H. B. ROBINSON UNIT NO. 2

INSULATION AND PIPING AFFECTED BY FAILURE

OF "C" REACTOR COOLANT PUMP SEAL, MAY 2, 1975 FOLLOW-UP REPORT

GRAPH 1

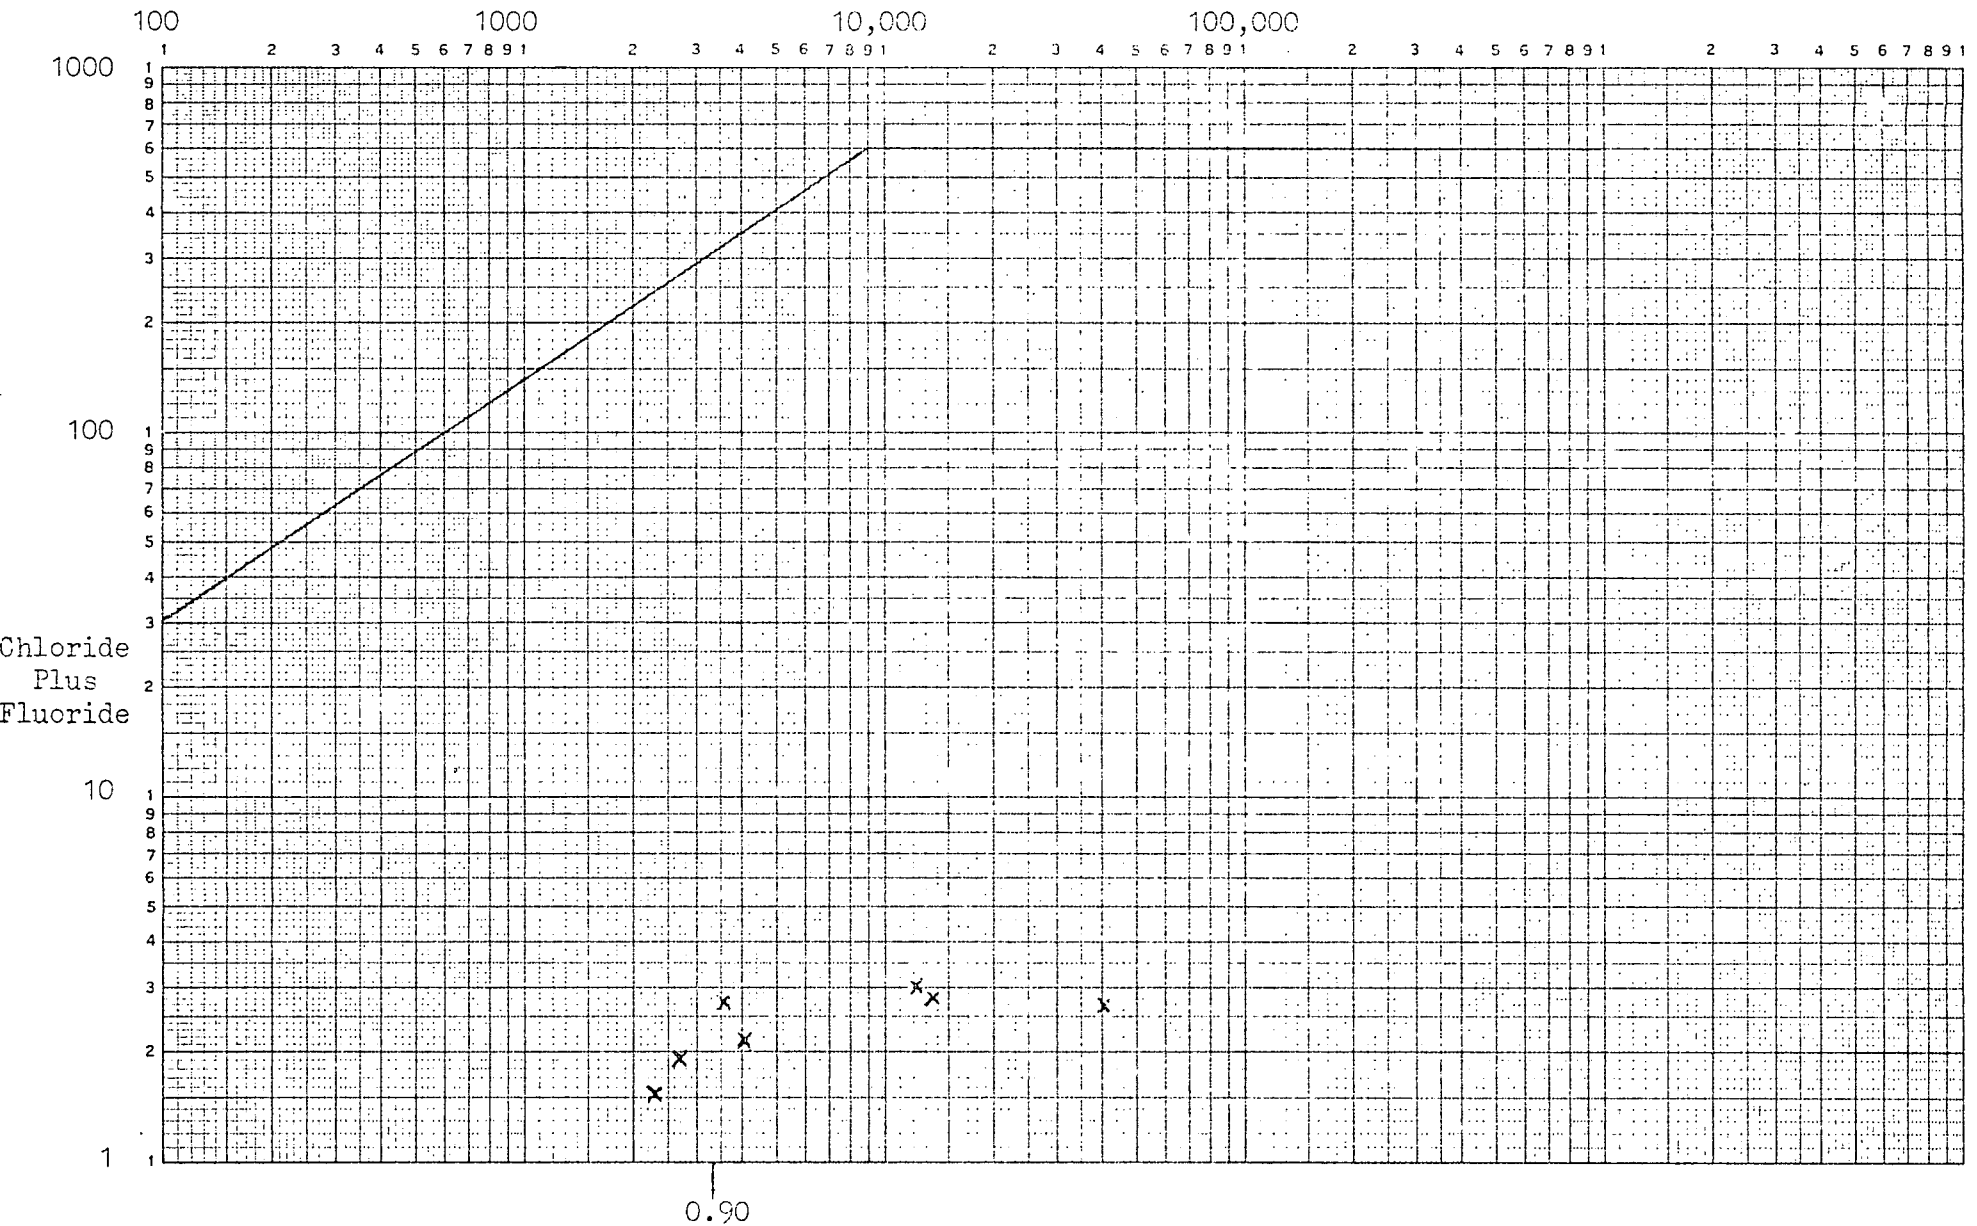
Corrected plant data in Table II of CPS-75-078 is erroneous in at least three instances if Table I was used as basic data for conversion as stated.

Graphs 1 and 2 of Mr. Utley's letter do not specify units used for plotting the curves and respective data.

Corrected Tables I and II from the Westinghouse Electric Corporation letter CPS-75-078 of June 3, 1975 and Table 2 from the Carolina Power & Light Company letter of June 13, 1975 are enclosed. Also a corrected Graph 1 is included to correspond with the corrected data in the tables mentioned above.

The units (PPM) used for plotting the curves and respective data on Graphs 1 and 2 are the same as for Figure 1 shown in Regulatory Guide 1.36.

LINE DIAGRAM 3

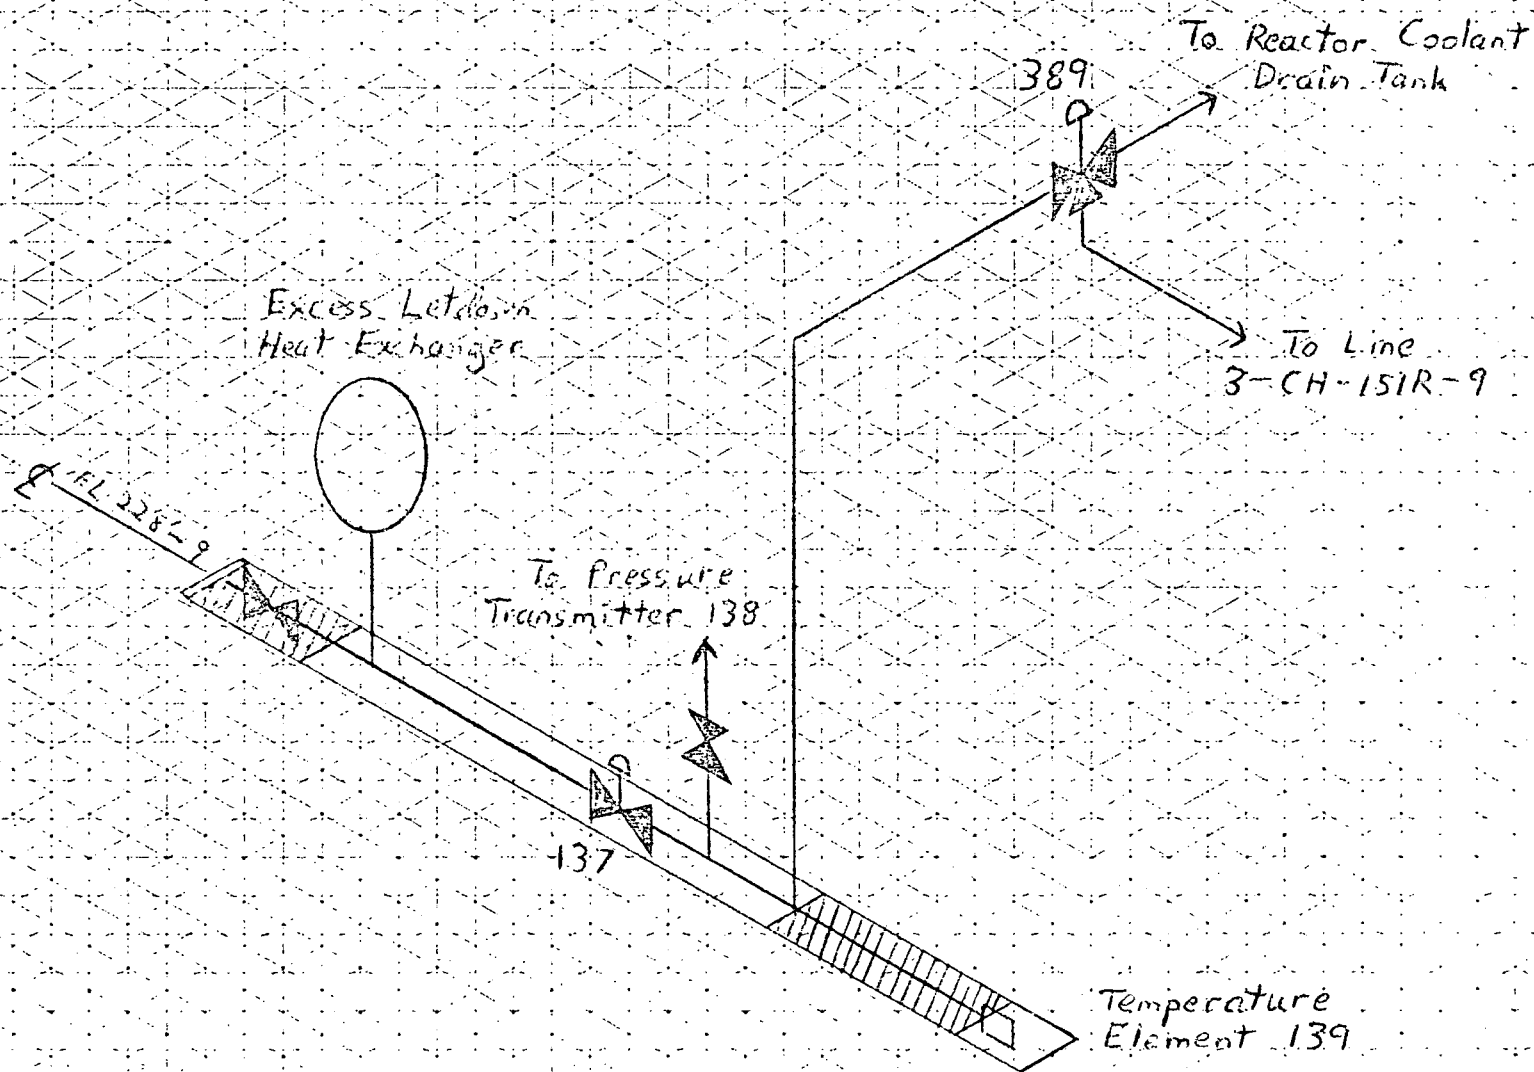
Charts showing the field location of the sampled piping insulation are illegible.

Drawings are attached which more clearly indicate the affected pipe and insulation.
